NEA/RWM/PEER(99)3

NUCLEAR ENERGY AGENCY  
RADIOACTIVE WASTE MANAGEMENT COMMITTEE

### International Peer Reviews

Exchanged comments and responses as preparation for the workshop  
between the OECD/NEA international review group and the JNC staff

Figure 1 T-H analysis model.

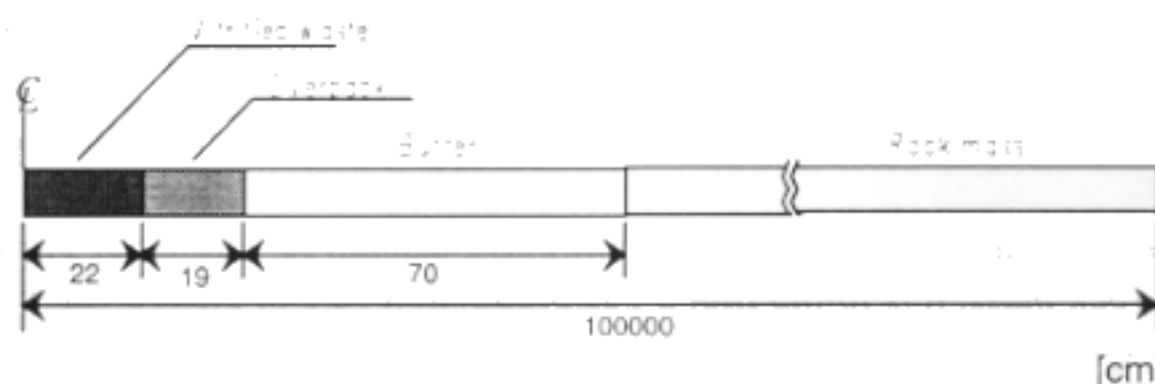
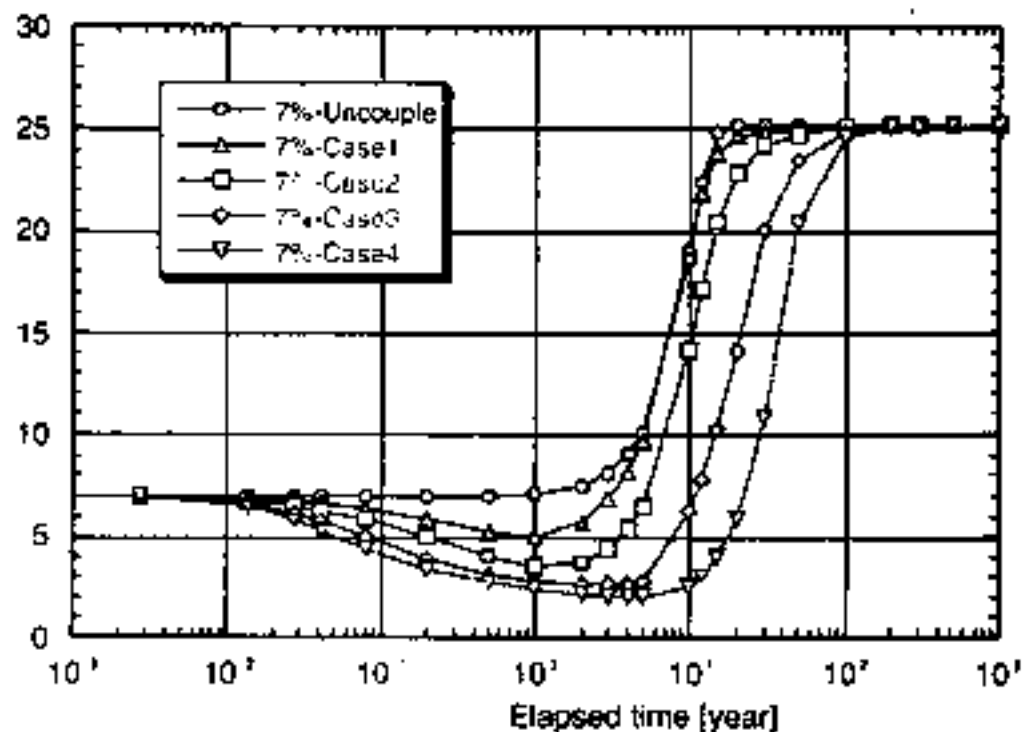
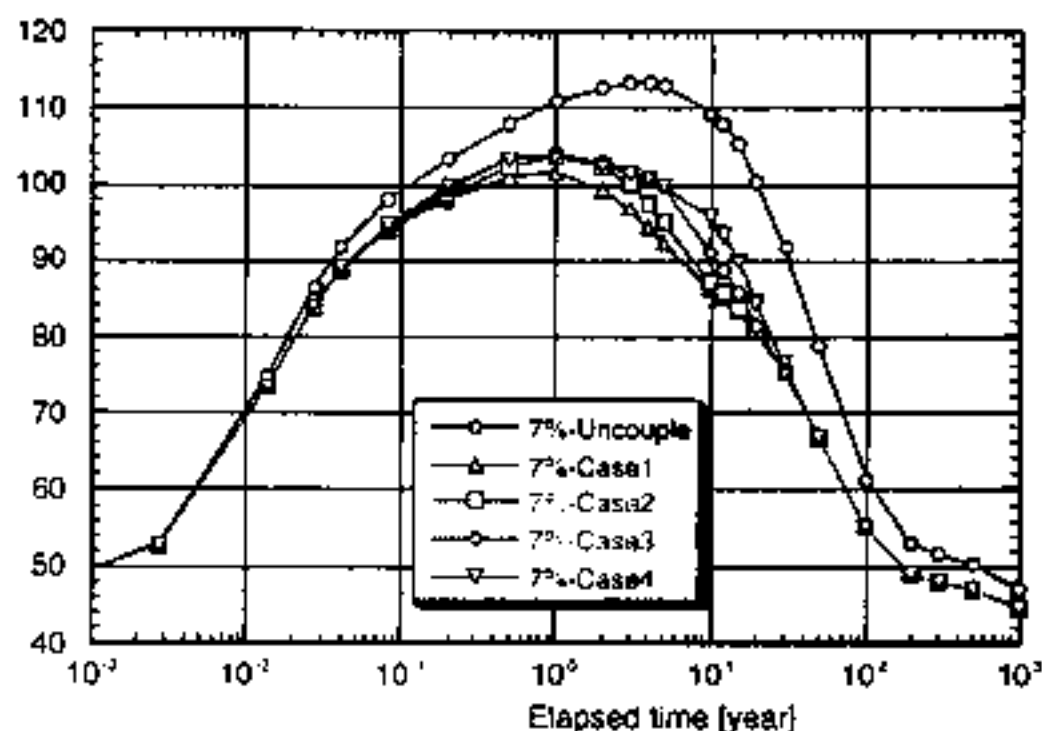
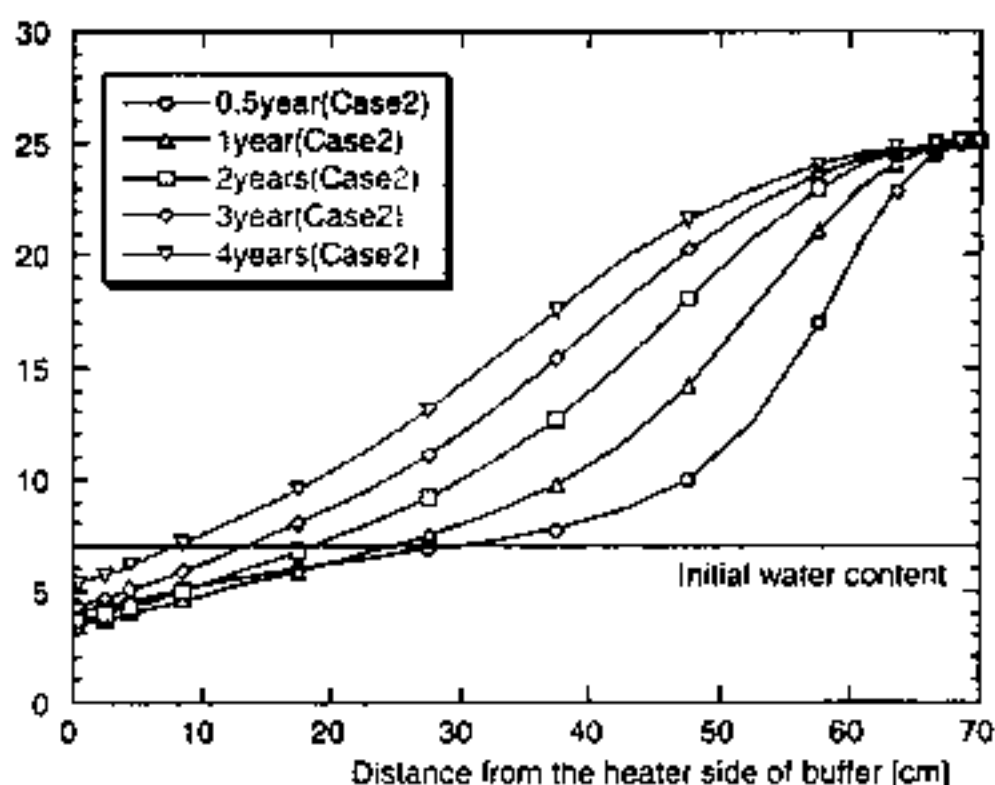
4-30.1 (Pages IV-88 and IV-89):THM analysis: In order to be conservative in a thermal analysis, the data for the thermal conductivity of the buffer material should be those corresponding to the lowest water content state. This value does not correspond with the initial water content of the buffer (see Figure 4.3.3-18 (a) of the "Supporting Report 2: Repository Design and Engineering Technology").

In Figure 4.3.3-18 (a) the water content of the inner part of the buffer material is lower than the initial water content during the first 25 years. Therefore, the initial temperatures of the inner part of the bentonite in a THM analysis should be higher than in the case of an uncoupled thermal analysis with the initial water content state of the buffer but in Figure 4.3.3-20 (a) is the opposite.

Then, it should be more conservative to use the THM coupled analysis than the uncoupled thermal analysis with the initial water content of the buffer. In the case of using a thermal analysis the water content should be the lowest value of the THM analysis, but not the initial water content.

=> We carried out the parametric study to compare the maximum temperature in the buffer between the thermal analysis and coupled T-H analysis. This result is described in the JNC technical report "Coupled thermal, hydraulic and mechanical analysis in the near field for geological disposal of high-level radioactive waste". The parameters were water content, thermal water diffusivity and pore pressure in the rock mass. The water contents for analysis were 7%, it is natural water content, and 17%, it is optimum water content of in-situ compaction. The thermal water diffusivity of buffer ( $D_{td}$ ) was determined by back analysis of laboratory test and was  $7.0 \times 10^{-8} \text{ cm}^2/\text{s}/^\circ\text{C}$ . In the parametric study, we set four cases, case 1 is  $D_{td} \times 0.5$ , case 2 is  $D_{td} \times 1.0$ , case 3 is  $D_{td} \times 2.0$  and case 4 is  $D_{td} \times 3.0$ . As a pore pressure in the rock mass, we used 0.0 MPa. Of course, the pore pressure in the rock mass is higher than 0.0 MPa. However, we considered that 0.0 MPa is a conservative value. The reason is that water content becomes low because water inflow rate into the buffer from the rock mass is low when the pore pressure in the rock mass is low. Lastly, we considered the case that rock mass was no flow as the special case, that is, water did not inflow into the buffer from the rock mass. In this case (Case 5), the thermal water diffusivity ( $D_{td}$ ) was  $7.0 \times 10^{-8} \text{ cm}^2/\text{s}/^\circ\text{C}$ . Analyses were performed using a simple model, as shown in Figure 1. Because the analysis model was simple (quasi-one dimensional model), we decreased the heat output of waste as the maximum temperature in the buffer approximately reached  $100^\circ\text{C}$ . In the case of an initial water content 7%, the heat output was 2/5 of the original heat output, and in the case of an initial water content 17%, the heat output was 1/2 of the original heat output.

Figure 2 shows the time history of water content in the buffer at the inner part of the buffer in the case of an initial water content 7% and Figure 3 shows the time history of temperature at the same point. In all cases of coupled analysis, water contents decrease from the initial values for a long time (3-20 years). However, the maximum temperatures of each coupled case are lower than that of the uncoupled case. Figure 4 shows the distribution of water content in the buffer for Case 2 (the initial water content is 7%).

At the inner part, the water content clearly decreases due to the thermal effect. However, at the outer part of the buffer, the water content increases due to the water movement from the inner part and water inflow from the rock mass. As results, the total water content in the buffer increases. We consider that this is a reason that the maximum temperature by the coupled analysis is lower than that by the uncoupled analysis, because the average value of the thermal conductivity among the overall buffer area increases with increasing the water contents by the groundwater infiltration from the rock mass.

Figure 1. Biosphere conversion factors normalised by the value of H12  
(for river type biosphere)

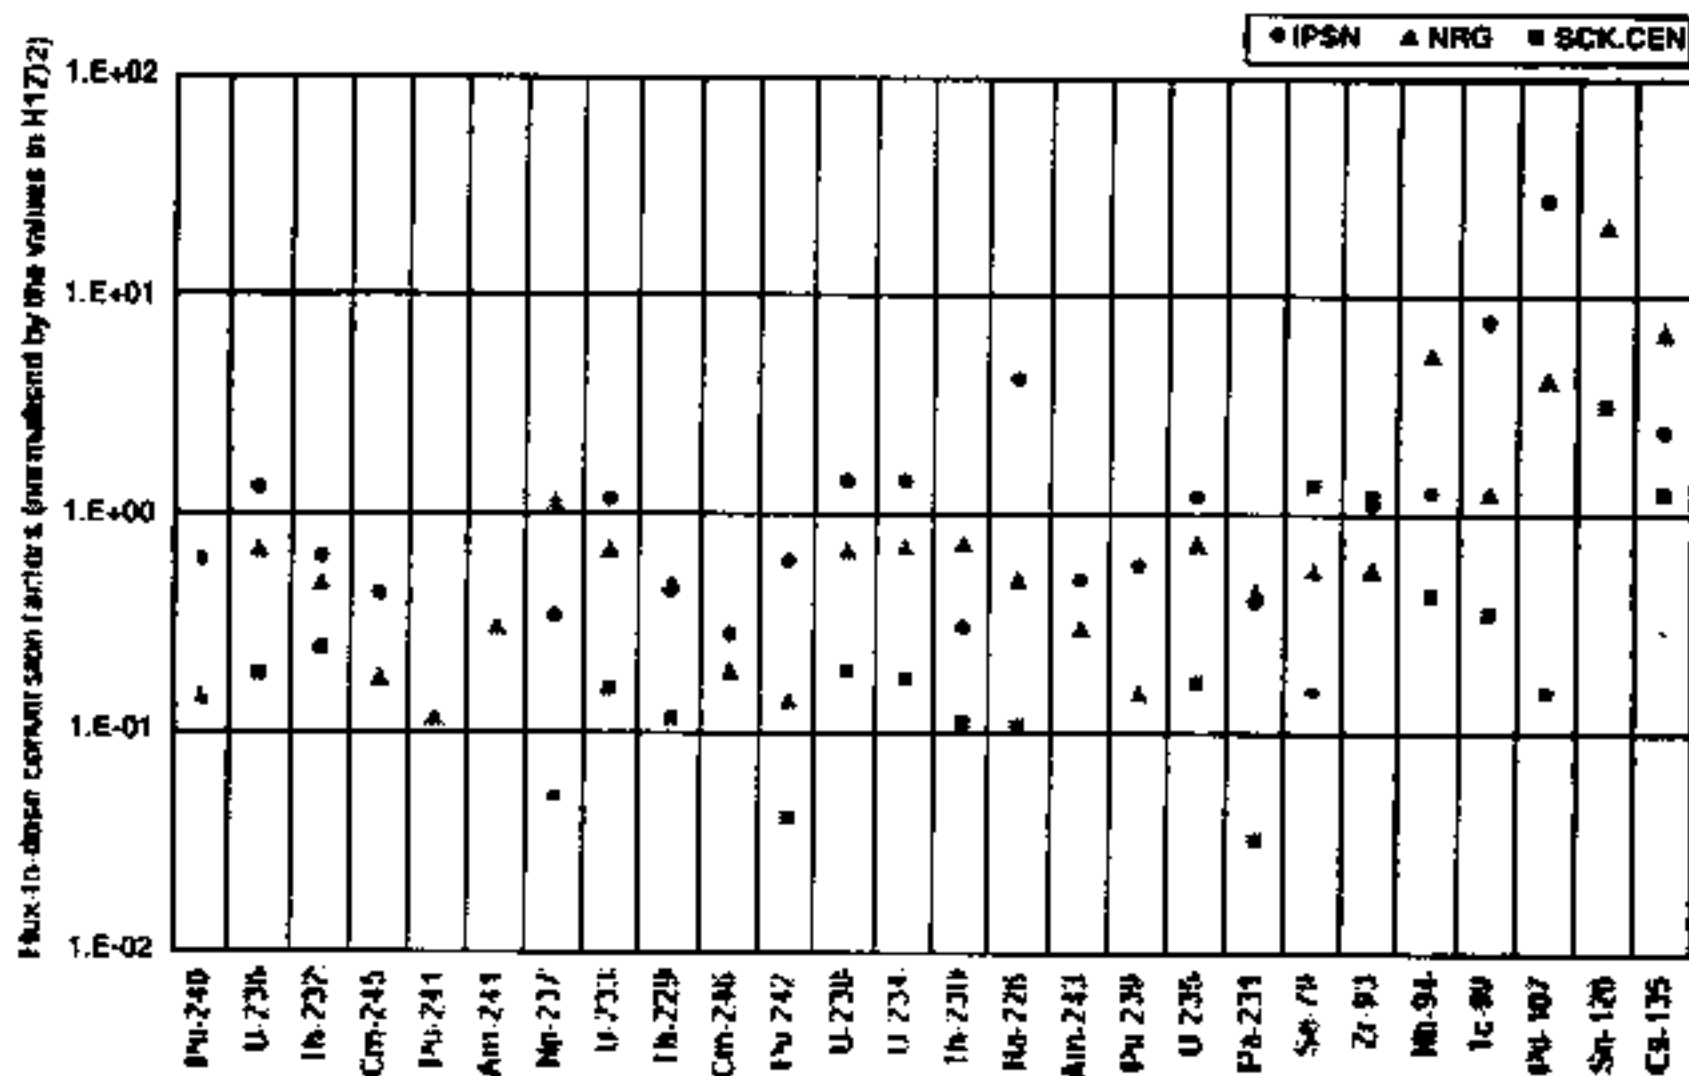
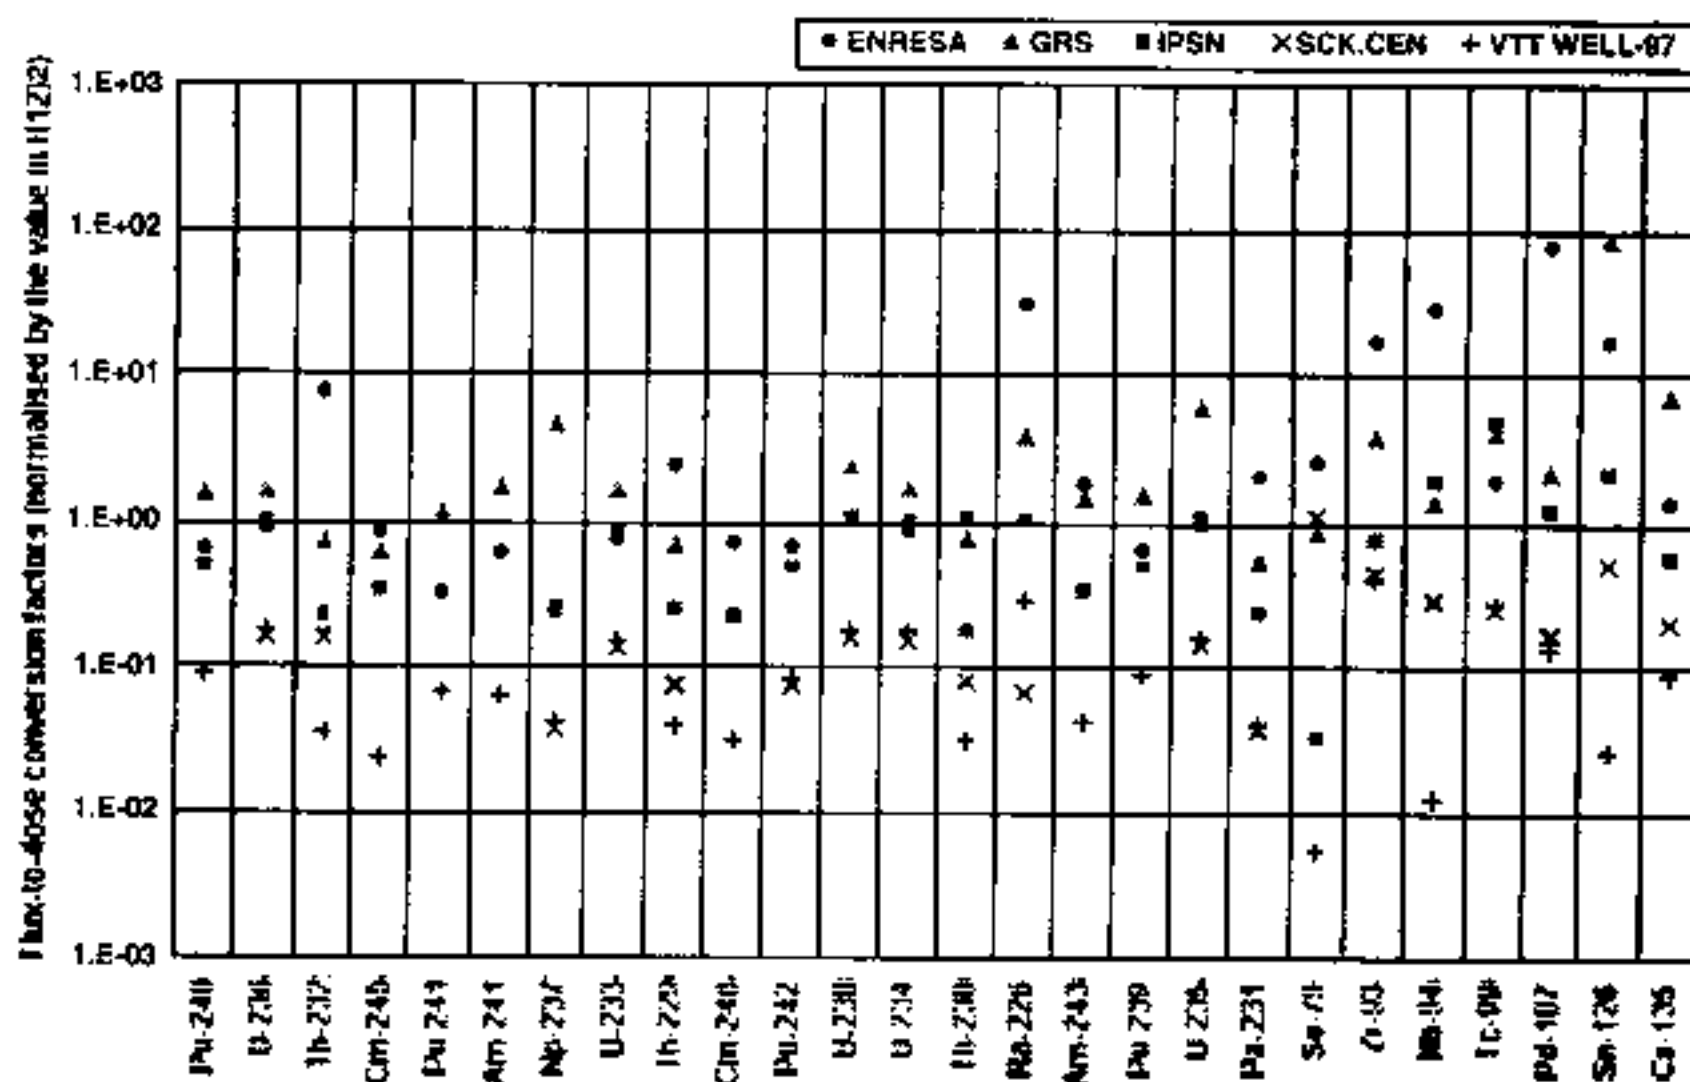
From both figures, it seems that the dose conversion factors of H12 are slightly *higher* than the corresponding values in SPA, except for some of fission products (notably Pd-107 and Sn-126). Looking at Figure 1, it can be seen that the factors for virtually all radionuclides lie within an order of magnitude of the H12 values (ie within the range 1E+1 and 1E-1) with most lying in the range 1E+0 to 1E-1. For Figure 2, the same pattern occurs with slightly more lying above the 1E+0 line and a few falling below the 1E-1 line (those falling below the 1E-1 line are primarily the VTT WELL-97 doses which only consider the drinking water dose - as noted in the SPA project, these doses are consistently lower than other doses due to the importance of pathways other than drinking water).
